Planning Commission Regular Meeting

Tuesday, December 2, 2025, 5:30 PM

Planning Commission Staff Report – Work Session

Subject: Stouffer House Rehabilitation and Landmarking Work Session
(PL-2025-0342)

A-1

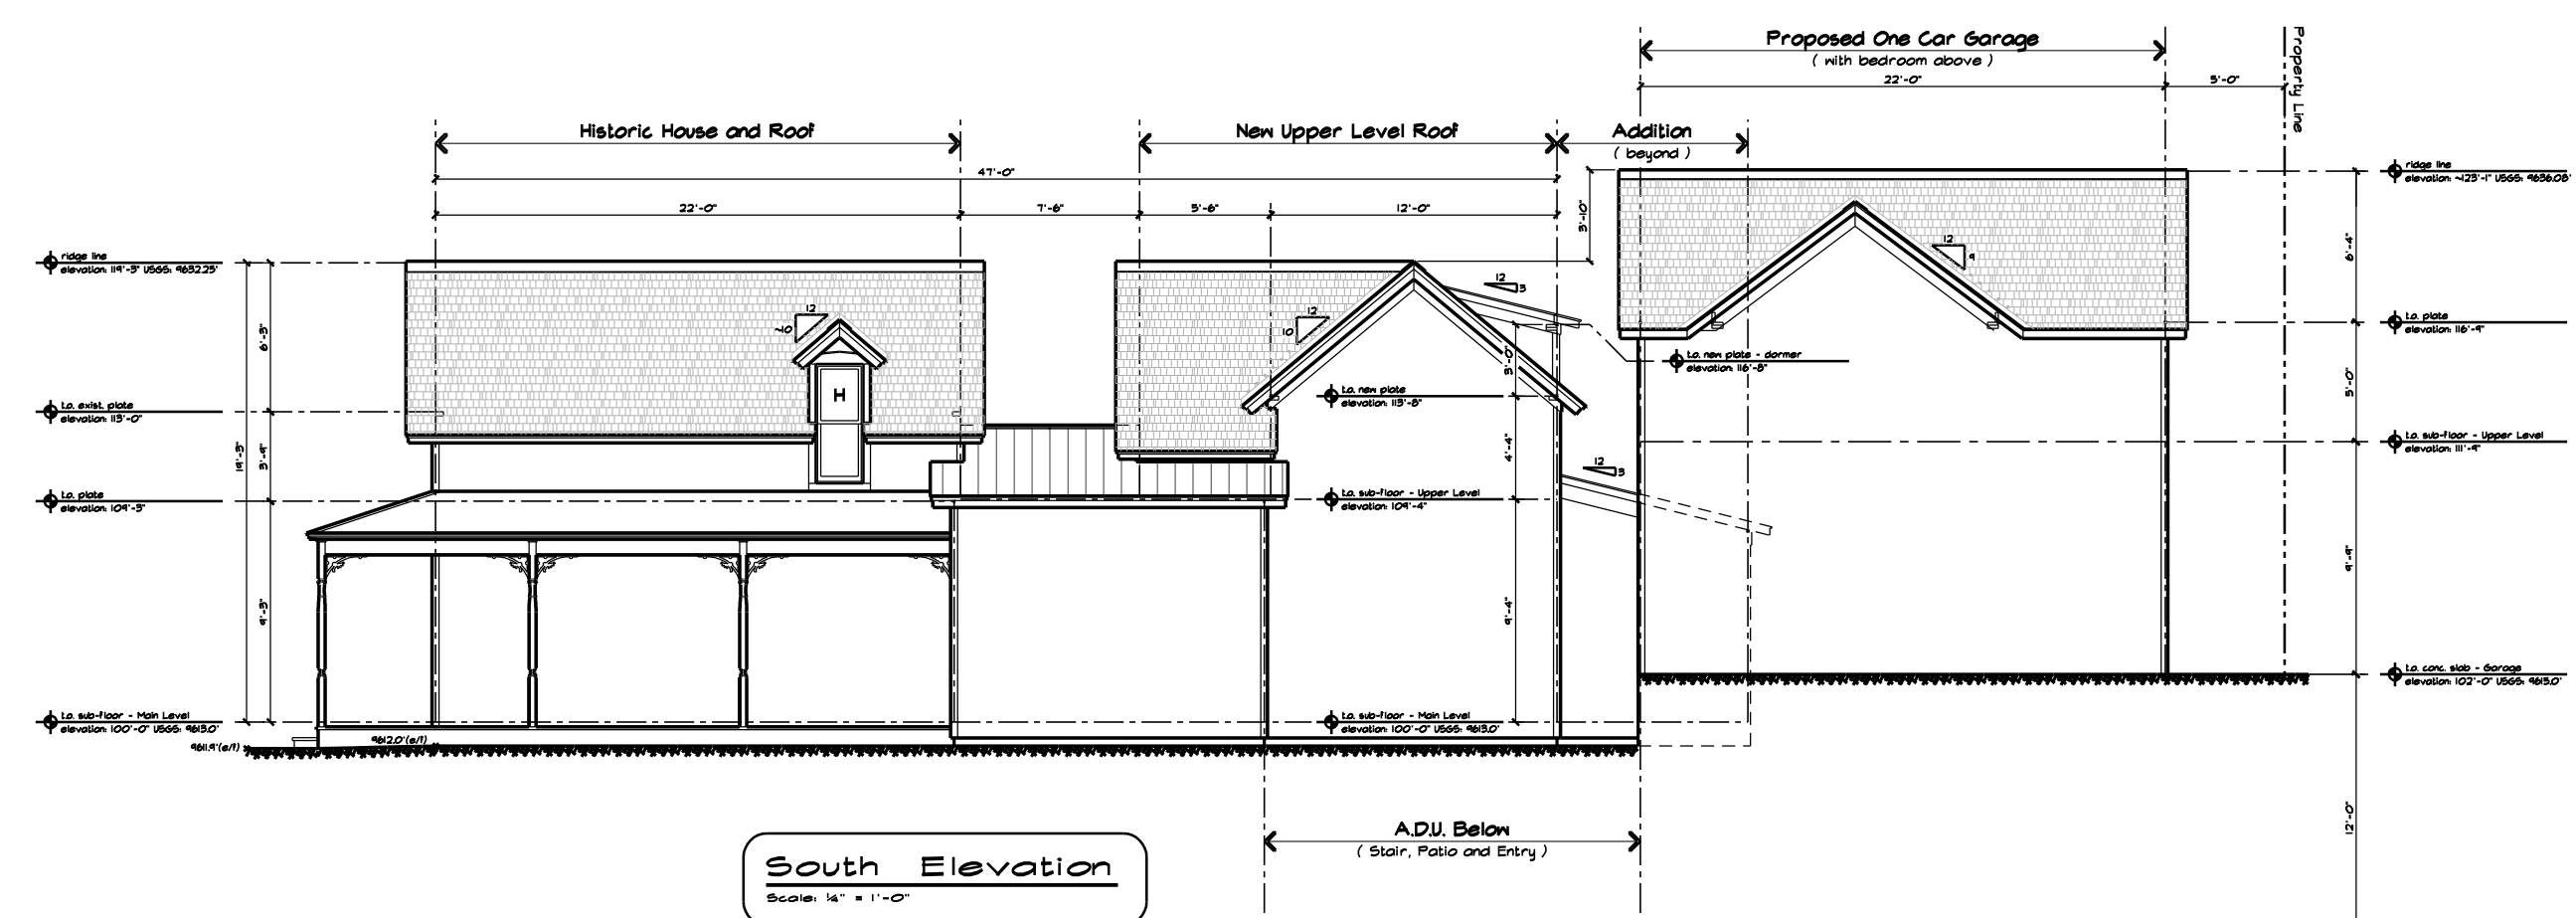
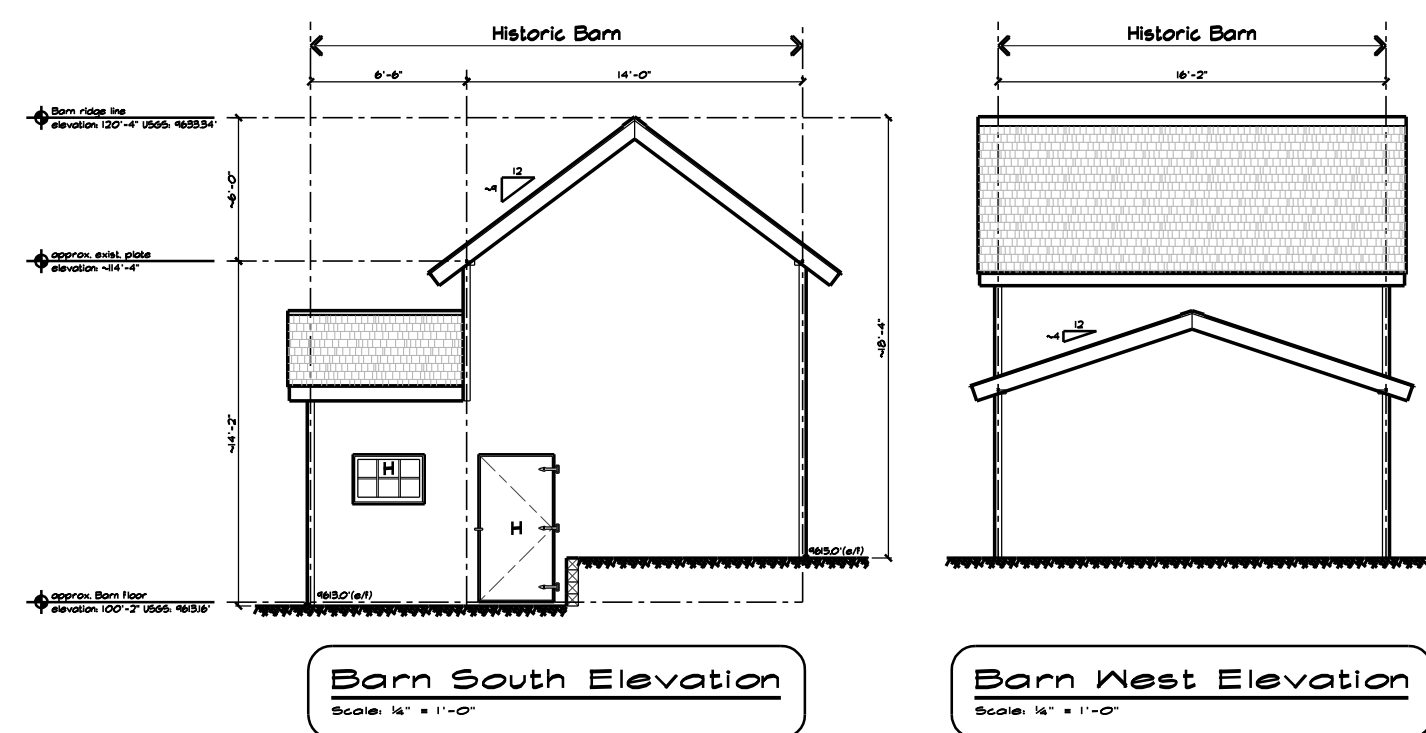
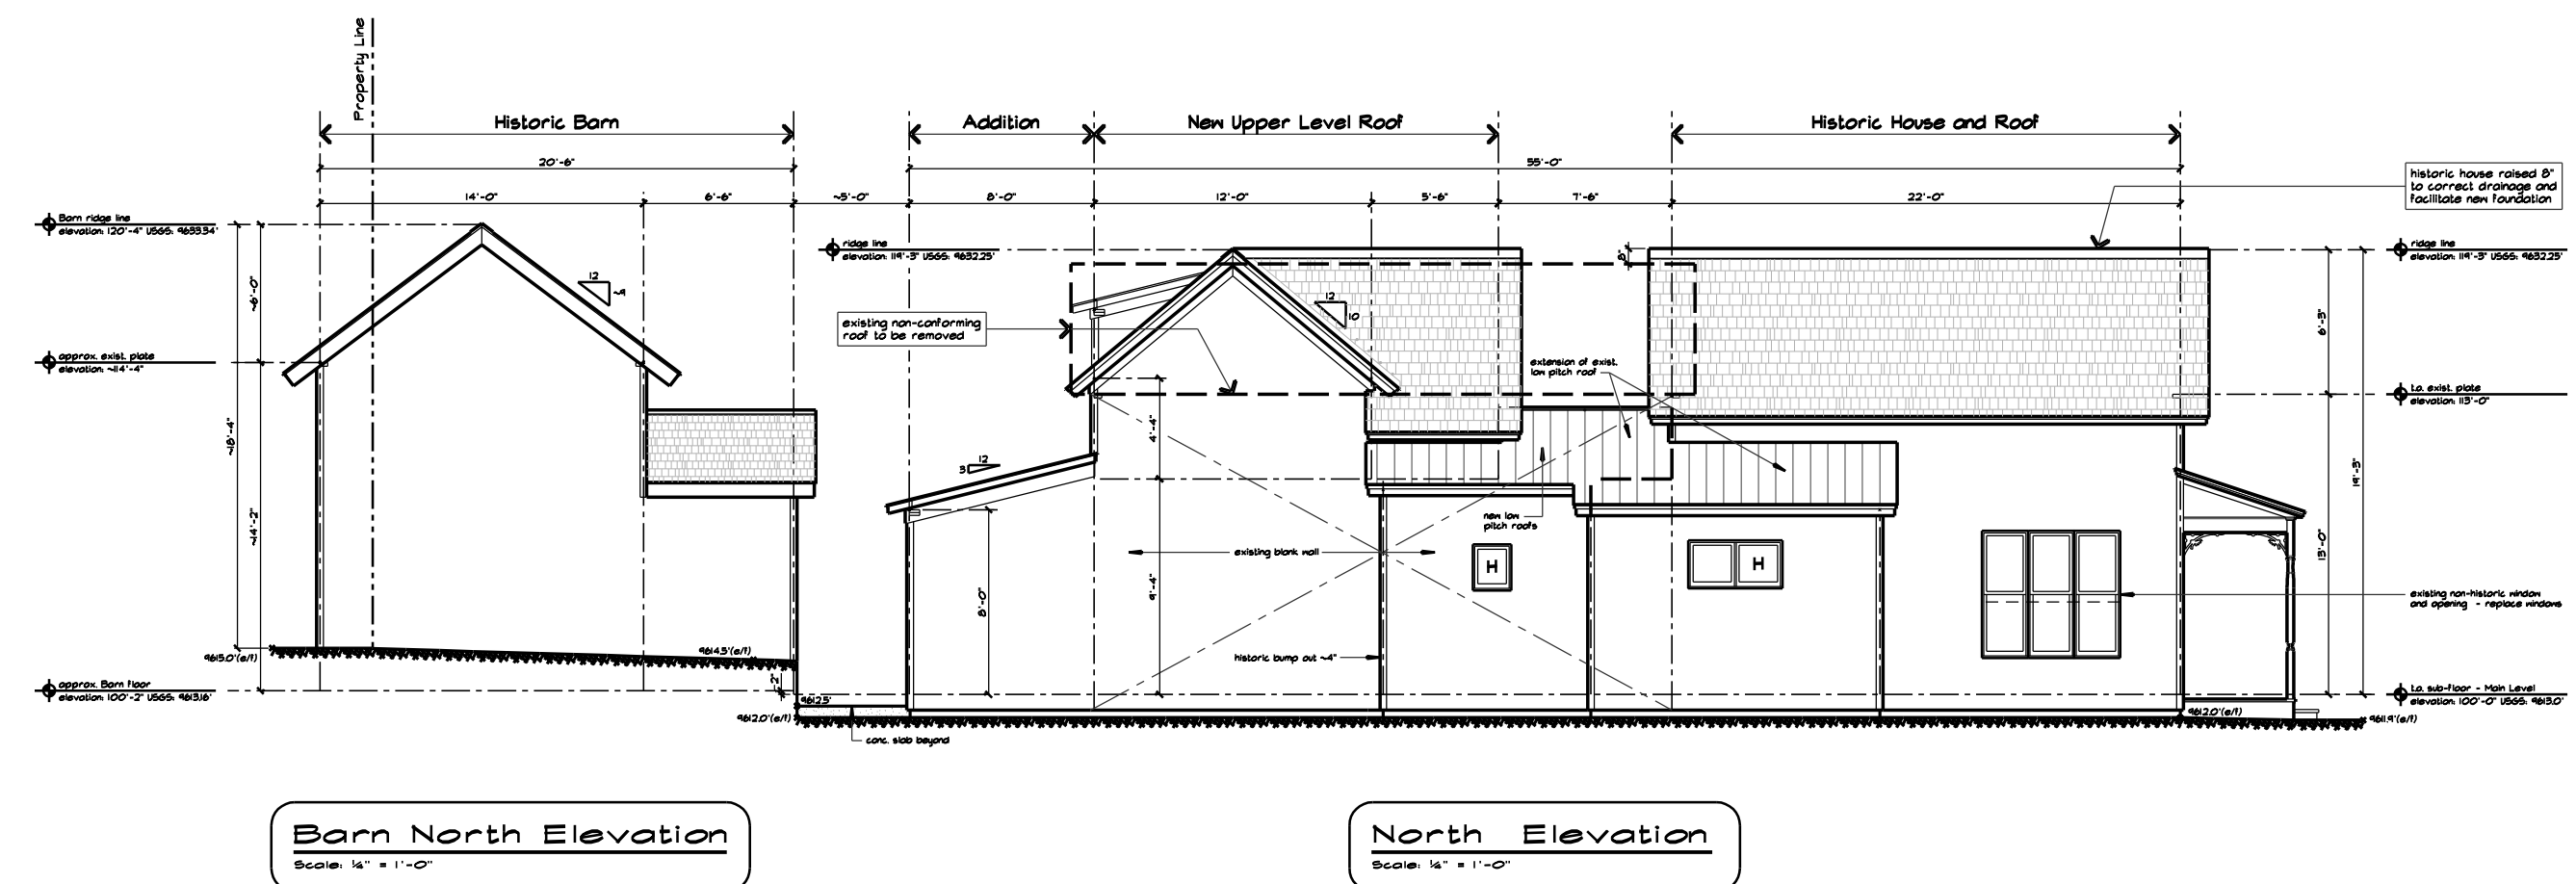
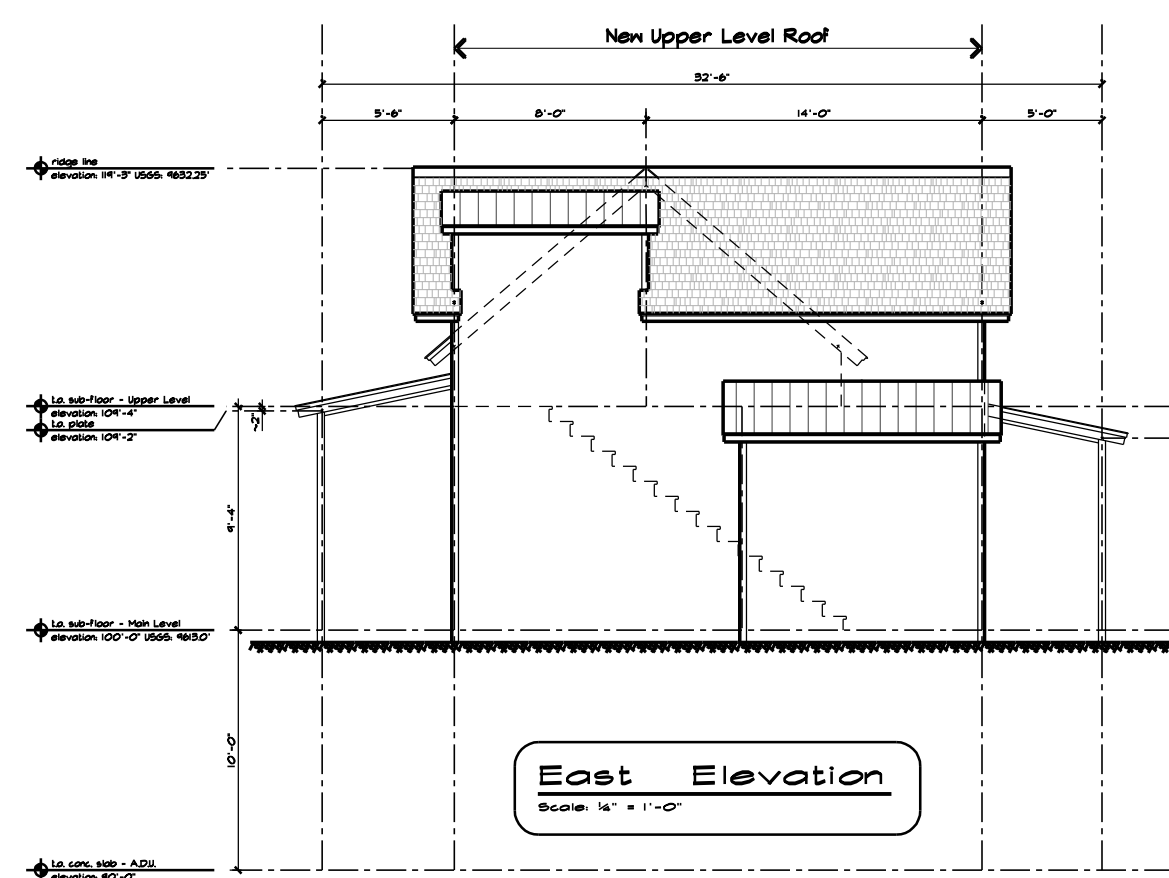
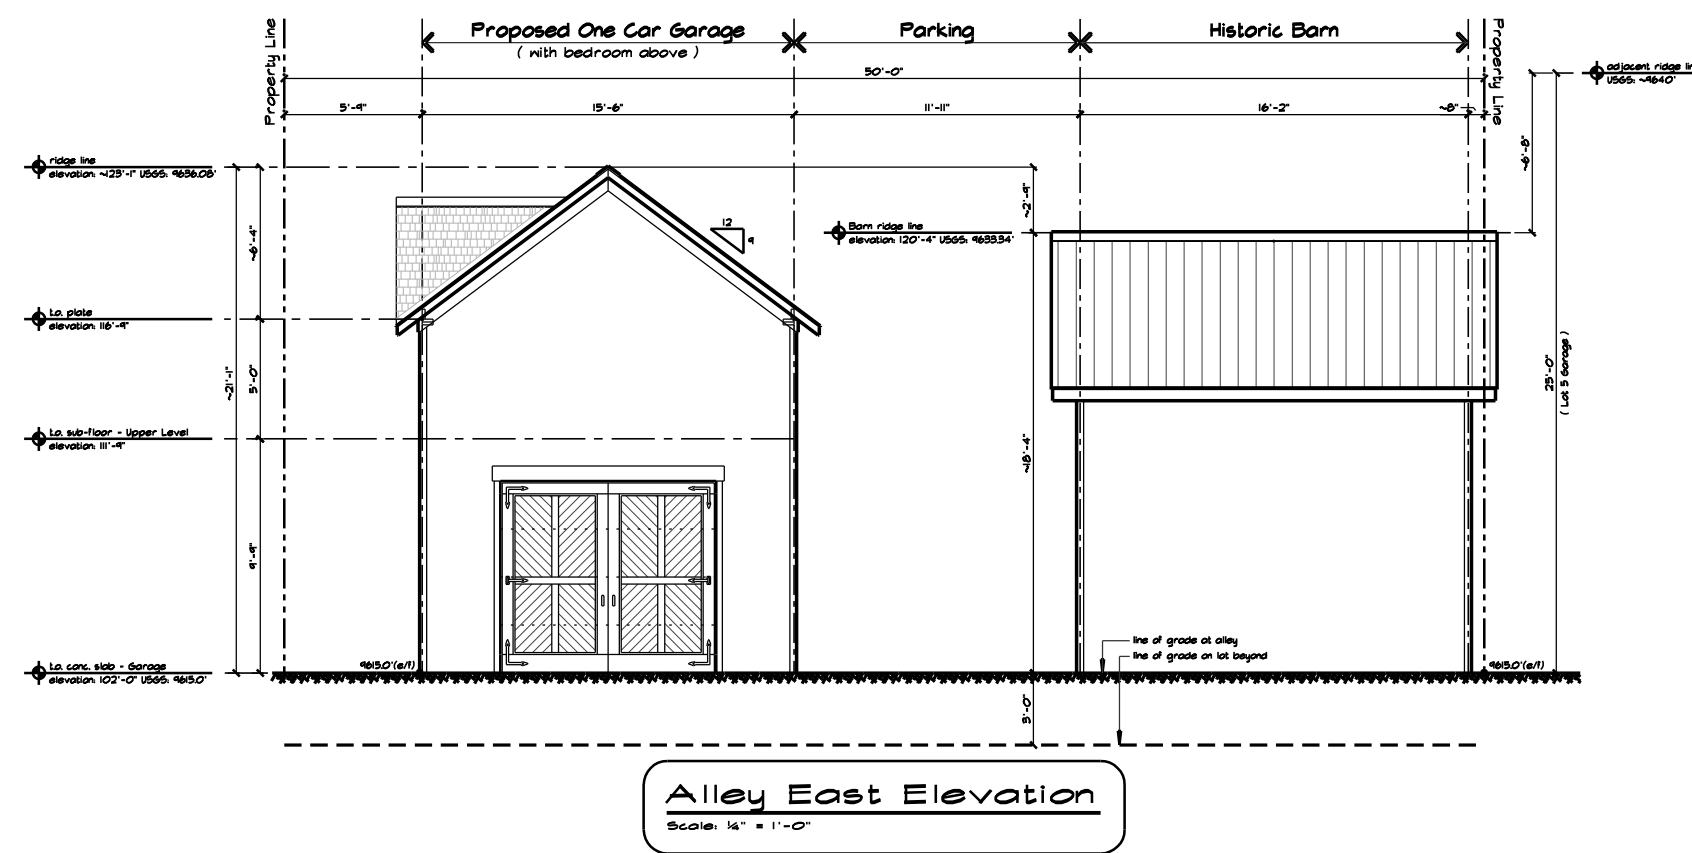
The current design proposes a lower-pitched “transition” roof within the historic footprint between the historic gable roof and the new two-story addition with a cross gabled roof. The applicant’s intent is to visually separate the original front-gabled module from the new work, while still providing usable upper-level space at the rear. The architect’s goal is to correct the current non-compliant ridge condition by restoring a more legible historic front mass and then stepping down before rising again to the new massing of the two-story addition. While we know there was a previous historic addition behind the existing historic portion that was removed, we can only discern the footprint of this historic addition. We have no information regarding the historic roof form which once existed behind the existing historic gable.

Staff finds that on this midblock lot, the addition will be mostly hidden behind the historic house when viewed from Harris Street right-of-way. It should be considered there will be angled views where the addition is partially visible beyond the side of the historic house. The proposed “transition” roof will cover a portion of the historic footprint and extend to the east outside of the historic footprint.

Staff is looking for high-level feedback on whether the overall roof massing and profile are consistent with the historic roof patterns described in the Handbook and East Side Residential Character Area standards.

1. Does the proposed low-pitched “transition” roof read as a form historically used in Breckenridge or does it introduce a form that is not compliant with the Character Area Standards, specifically Priority Design Standard 121?
